PRODUCT UPDATE

PRODUCT NAME: Hydraulic Gemini™ Monitor

AKRON PART NUMBER: 3475 and 3476

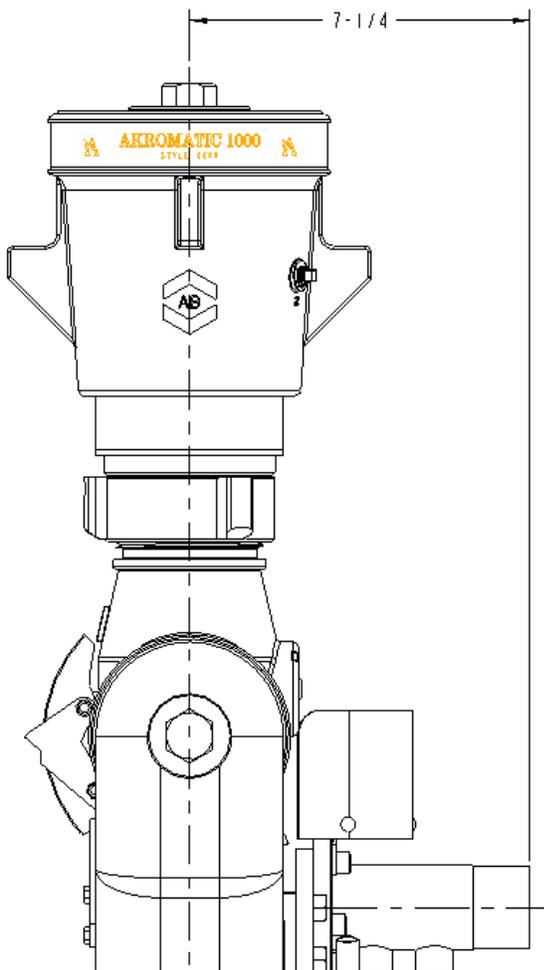
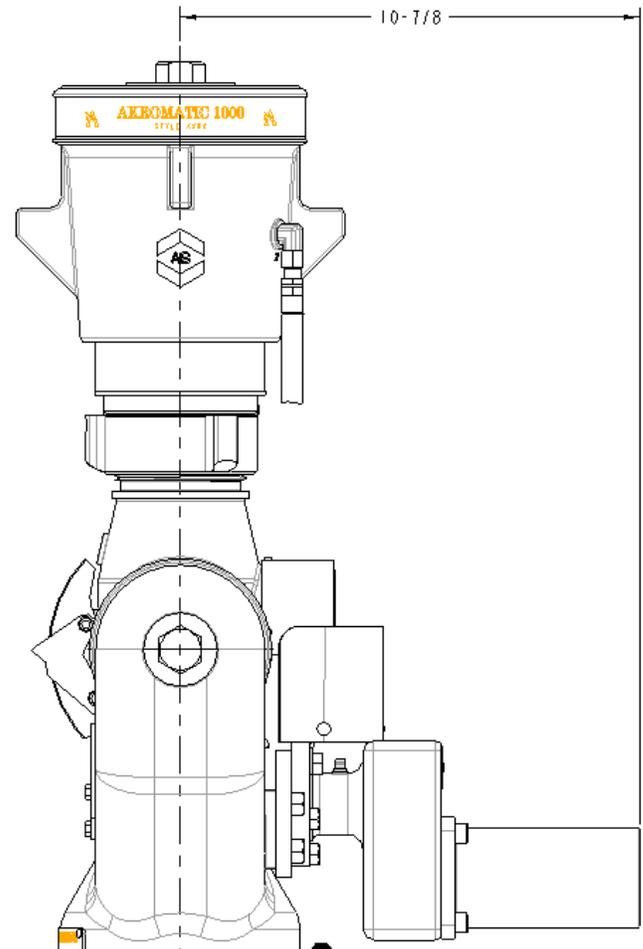
The 3475 and 3476 Hydraulic Gemini Monitors will only be available with the manual override gearbox. The motor used on the non-override monitors has been discontinued and is no longer available. The gearbox will change the dimensions of the monitor making it slightly larger. Existing monitors in the field can be changed over to the override style motor/gearbox. The part numbers needed for the changeover of existing units in the field are:

Please see the drawings below for the specific dimensions.

Old Dimensions

New Dimensions
